**ADDENDUM TO
WEST DON LANDS
CLASS ENVIRONMENTAL
ASSESSMENT MASTER PLAN
FOR STORMWATER QUALITY**

**City of Toronto
Waterfront Toronto**

FINAL REPORT

RVA 071345

OPTIONS FOR STORMWATER TANK LOCATIONS

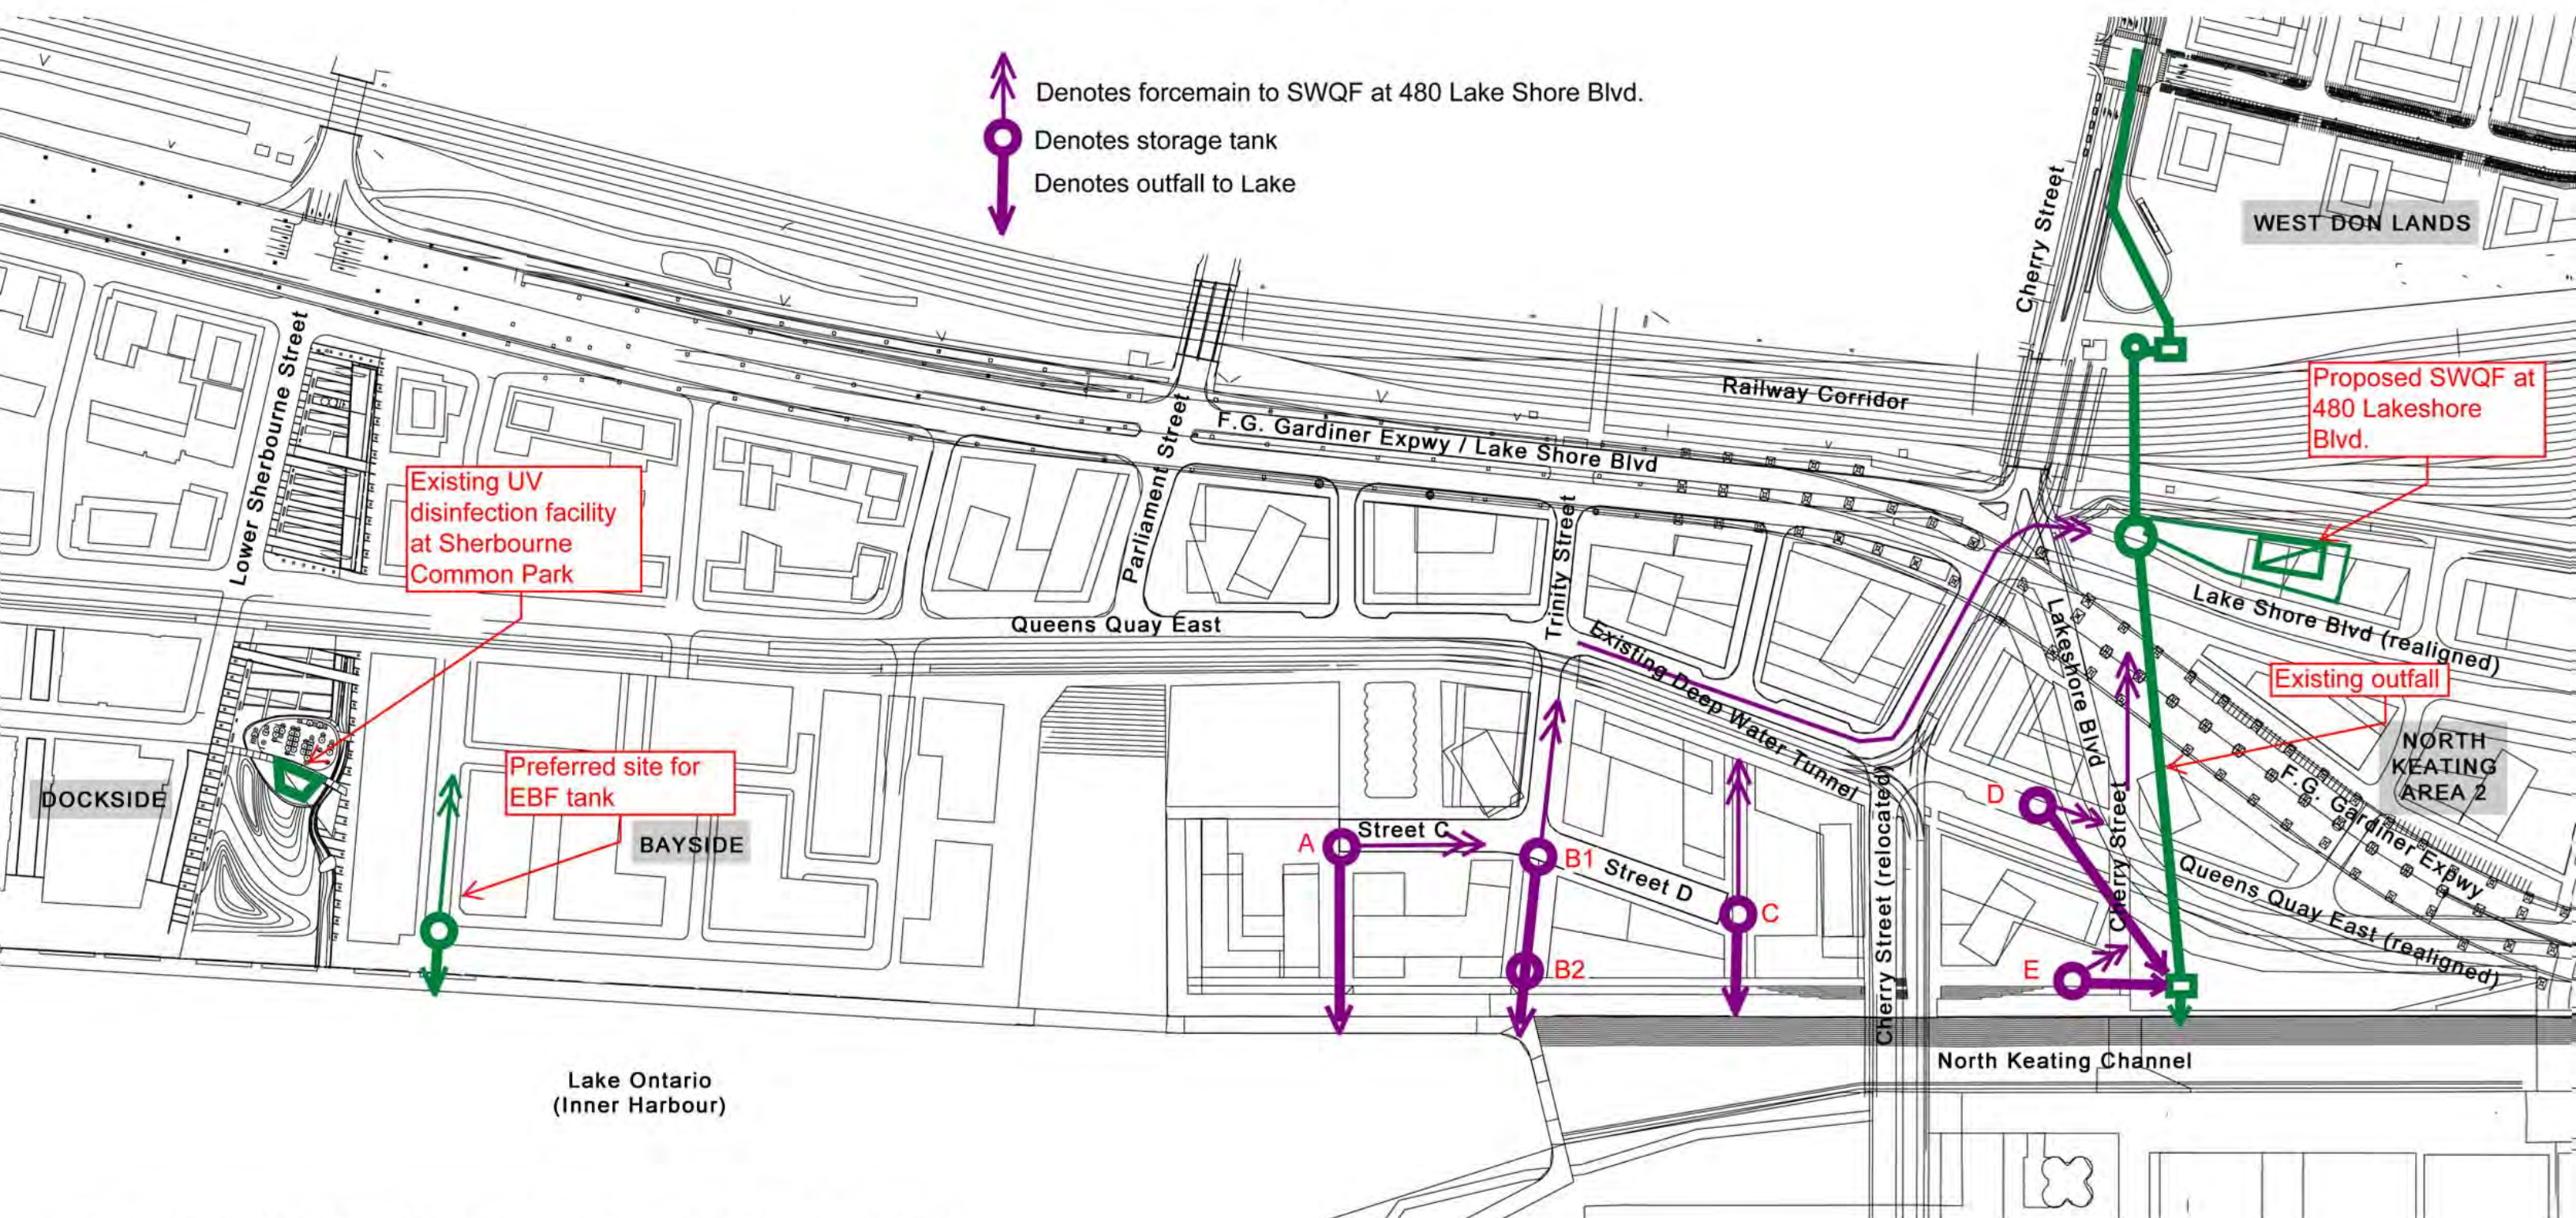
As discussed at the meeting on March 14, 2013, the proposed options are fine with the exception of Option C. Option C is proposing a stormwater tank in a ROW that is not identified as public under the City Council adopted Zoning Bylaw No. 1174-2010. Can you please remove Option C in your EA Addendum package. In any event, we do not see it as an appropriate location for the stormwater tank location.
